Request for Information Response

RFI Number: R-AW071

ARAPAHO ROAD - PHASE III
 SURVEYOR BOULEVARD TO ADDISON ROAD
 PAVING PLAN AND PROFILE
 STA 75+00 TO STA 80+00

TOWN OF ADDISON, TEXAS

Design	JSM	Drawn	GFS	DATE	SCALE	PROJECT NO.	SHEET NO.
Check	JOH	Check	JSM	APRIL 04	1" = 20' 1/4" = 5'	25768	PP-11

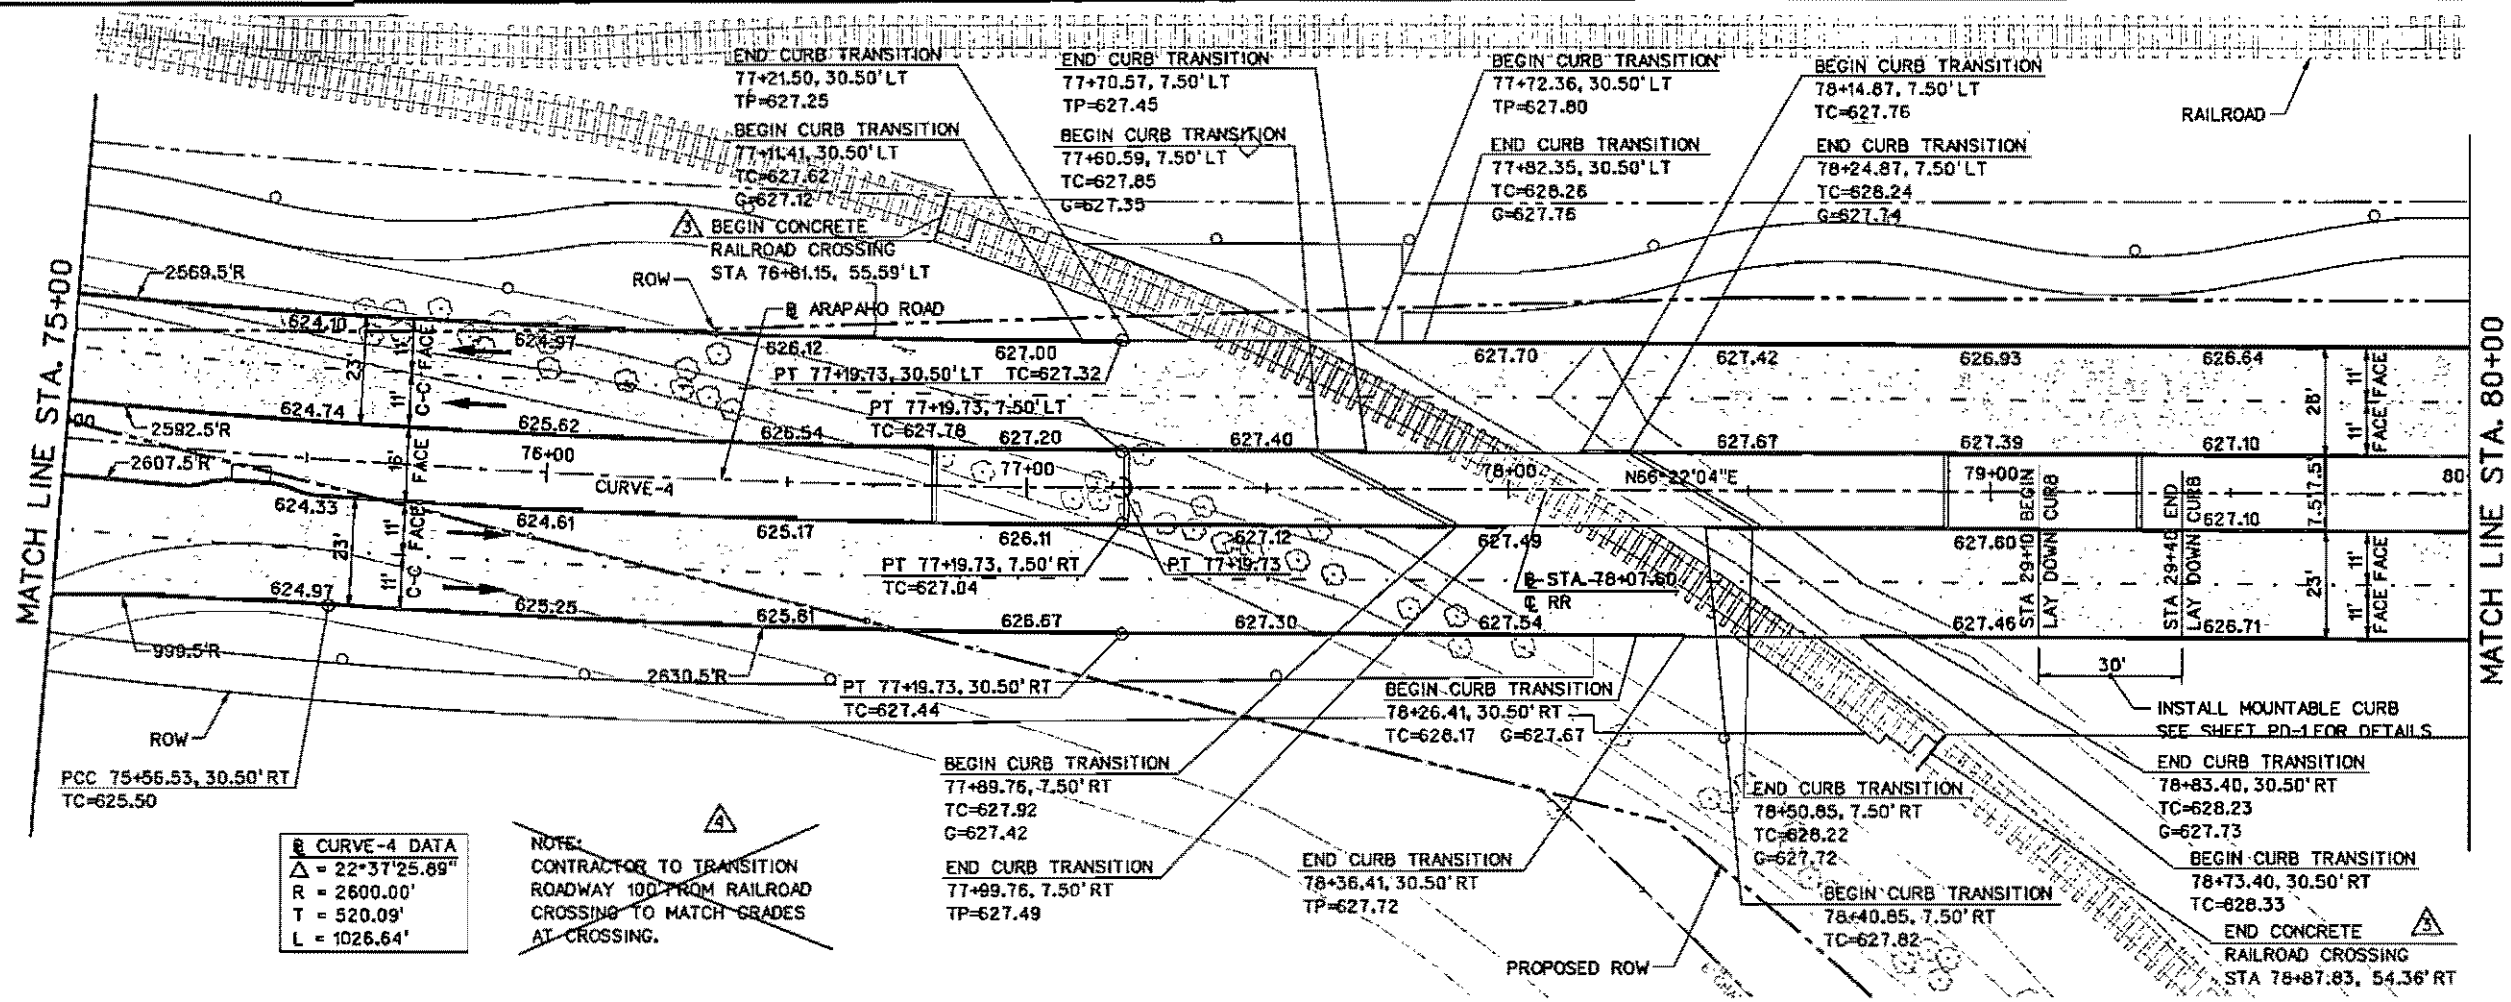
NO.	DATE	REVISION	APPROV.
4	1-17-05	REVISED GUTTER SPOT ELEVATIONS	JOH
3	5-24-04	ADDED NOTES	JSM

Attached to this response are three contract drawing with the grade elevation shown along the roadway curb line. The information included on the plans should answer all questions above. Archer Western Contractors, Ltd. will be official issue these three contract drawing with the grade at a later date.
